Access Compliance Report

Public Rights-of-Way

Intersection ID: 11625	Main Street: E_11TH_ST	Cross Street: N_COLLEGE_ST	Location: N
ADA ID: 7B95ED8AF6D0	Ramp Type: BlendTrans1	Initial Pass/Fail: Fail	Overall Compliance: No
Severity Score: 10			
Codes/Mitigation Info/Possible Solution		Field Measurements/Component Compliance

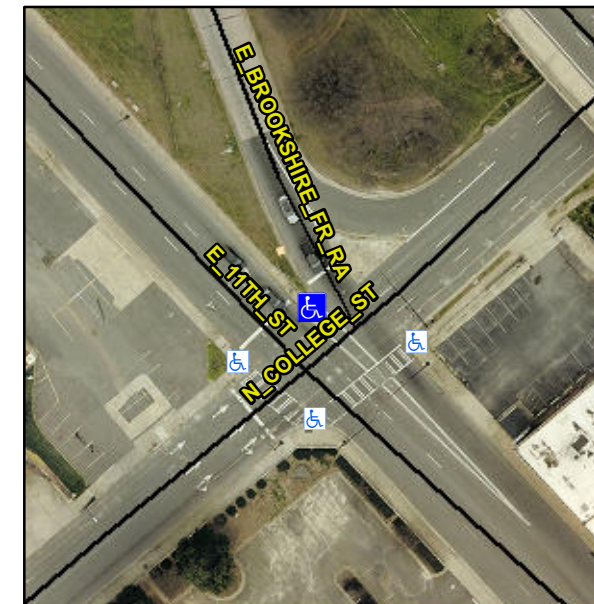
Not Found, R304.5.1, R304.5.3

Compliance	Description	Data	Compliance	Description	Data
N/A	Ramp Length (in)	32.0	Yes	BlendTrans Slope (%)	1.9
No	Ramp Width (in)	47.5	No	BlendTrans XSlope (%)	2.8
N/A	Flare Type LT	N/A	N/A	Flare Type RT	N/A
N/A	Flare Slope LT (%)	N/A	N/A	Flare Slope RT (%)	N/A
N/A	Flare Traversable LT?	N/A	N/A	Flare Traversable RT?	N/A
N/A	Landing Length (in)	N/A	N/A	DWS Provided?	N/A
N/A	Landing Width (in)	N/A	N/A	DWS Contrast?	N/A
N/A	Landing Slope (%)	N/A	N/A	DWS Length (in)	N/A
N/A	Landing X Slope (%)	N/A	N/A	DWS Full Width?	N/A
N/A	Landing Curb? (Y/N)	N/A	N/A	DWS Offset (in)	N/A
N/A	Shared Landing?	N/A			
N/A	Gutter Ponding?	N/A	N/A	Gutter Slope (%)	N/A
N/A	Gutter Lip Ht (in)	N/A	N/A	Gutter X Slope (%)	N/A
N/A	Painted X Walk1?	No	N/A	Painted X Walk2?	N/A
	X Walk 1 Direction	To SW		X Walk 2 Direction	N/A
	X Walk 1 Width (in)	N/A		X Walk 2 Width (in)	N/A
	X Walk 1 Slope (%)	3.2		X Walk 2 Slope (%)	N/A
	X Walk 1 X Slope (%)	1.6		X Walk 2 X Slope (%)	N/A

N/A	Ramp inside XWalk1?	N/A	N/A	Ramp inside XWalk2?	N/A
	Road Slope (%)	1.6		Clear Space?	N/A
	Road X Slope (%)	3.2	N/A	Clear Space to XWalk (in)	N/A
N/A	Any Obstructions?	N/A	N/A	Storm Grate/Utility Hazard?	N/A
	Obstruction Type			Storm Grate/Utility Type	
		N/A			N/A
			Yes	Surface Condition? (G/P)	Good
			No	Curb Slope (%)	14.3

Remove & Replace Curb Ramp With Two New Directional Ramps or Equivalent.
